Product Change Notification

MultiTech Conduit[®] IP67 Base Station

Product Change Notification (PCN) Number

PCN 01272022-001 (Conduit IP67 - mPower)

2. **Hardware Version:**

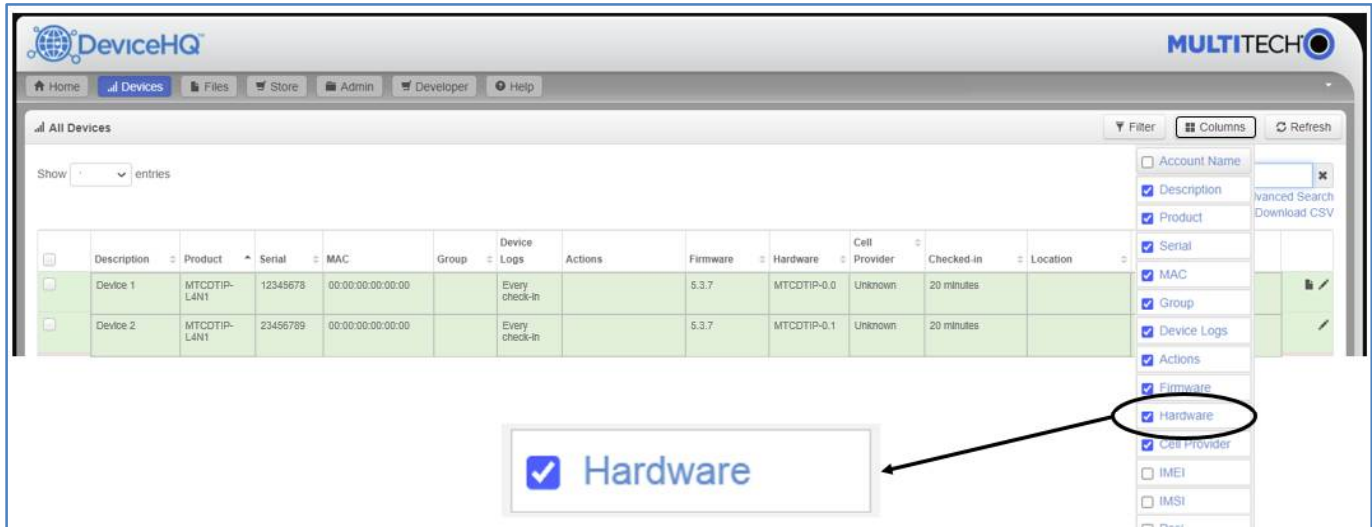
- MTCDTIP device with original components – Hardware Version “MTCDTIP-0.0”
- MTCDTIP with substitute components – Hardware Version “MTCDTIP-0.1”

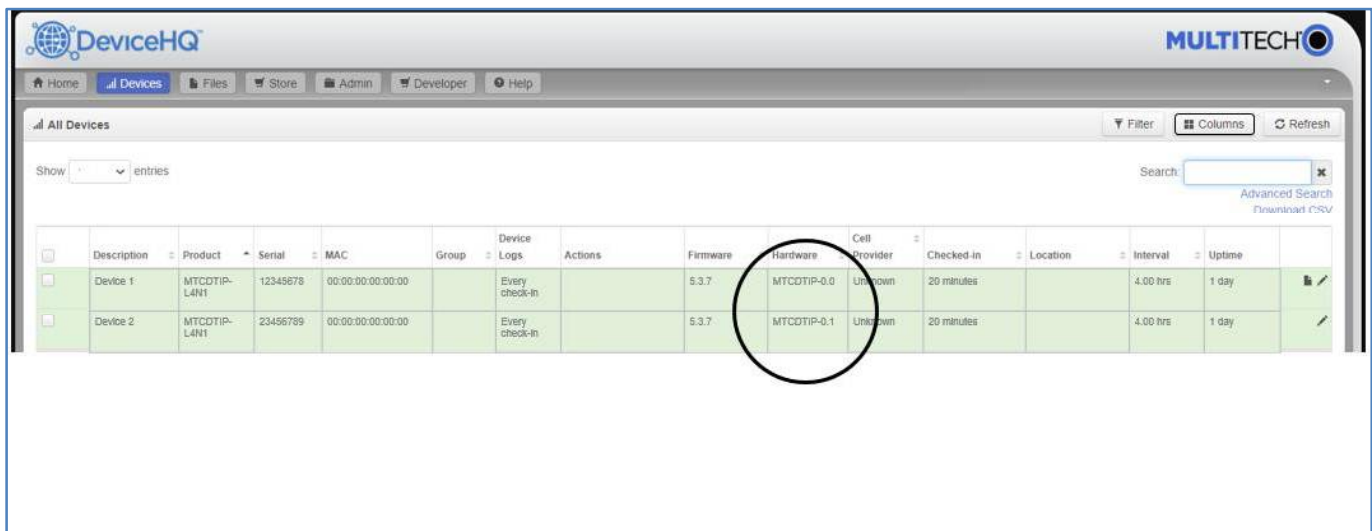
Once this selection is made, the DeviceHQ dashboard will show the hardware version of each device:

- **MTCDTIP-0.0** - MTCDTIP device with original components
- **MTCDTIP-0.1** – MTCDTIP device with substitute components
